**LONG CHIH INDUSTRIAL COMPANY LIMITED**  
101, Show Shan Road, Shinchuang City, Taipei Hsien, Taiwan, ROC  
Tel: 886-2-29068666 Fax: 886-2-2906-8669 E-mail: longchih@ms31.hinet.net

## **SAFETY RECALL NOTICE**

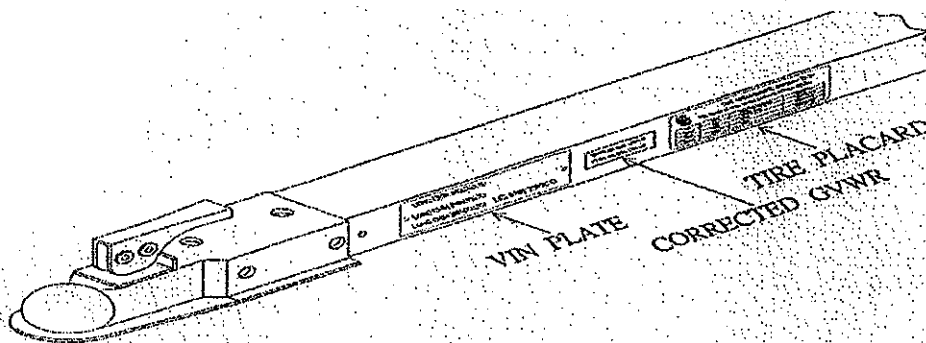
Enclosed with this letter is the correct tire placard label and GVWR label. Please affix these labels to the driver's side of the trailer tow bar near the VIN plate as shown below in this picture. Also enclosed is the "Reporting Safety Defects" statement as a part of owner's manual. Please read this statement and save it with

1. Clean the surface of the tow bar driver's side as on above diagram.
2. Please affix the provided corrected GVWR label first then tire placard on clean surface of tow bar.
